Loss of Configuration Information (Serial Data) in 9323/9360/9390 series transceivers.

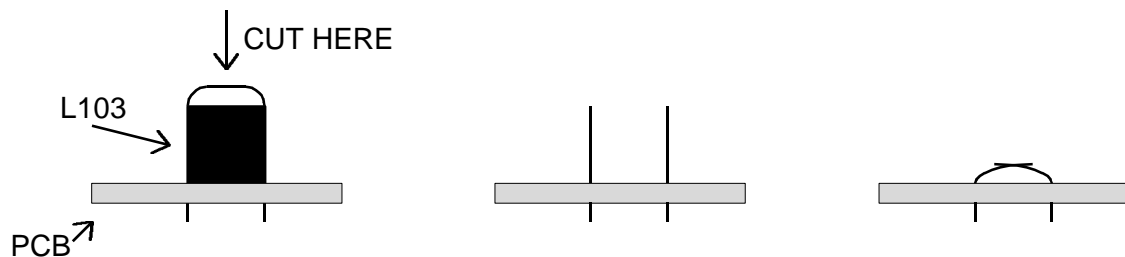
Remove L103, a choke located on the Microprocessor & Audio PCB, 08-04966.

1. Remove the transceiver from the installation, ensure the power is disconnected.
2. Remove the two screws securing the bottom cover and remove the cover.
3. Locate the Microprocessor and Audio PCB Assembly (08-04966-001).
4. Remove the 4 screws securing the top Microprocessor (μ P) shield. Remove the shield.
5. Locate L103, a ferrite bead inductor located adjacent to IC 101.
6. Using a pair of side cutters, cut the ferrite bead and the wire simultaneously. Remove the ferrite by sliding it up and off the wires. Ensure all traces of ferrite are removed from the PCB.

7. Bend the two wires towards each other so that they are flat on the PCB.
8. Trim off excess wire and solder the two wires together to form a link.
9. Replace the top μ P shield and secure with the 4 screws.
10. Replace the bottom cover and the 2 securing screws.
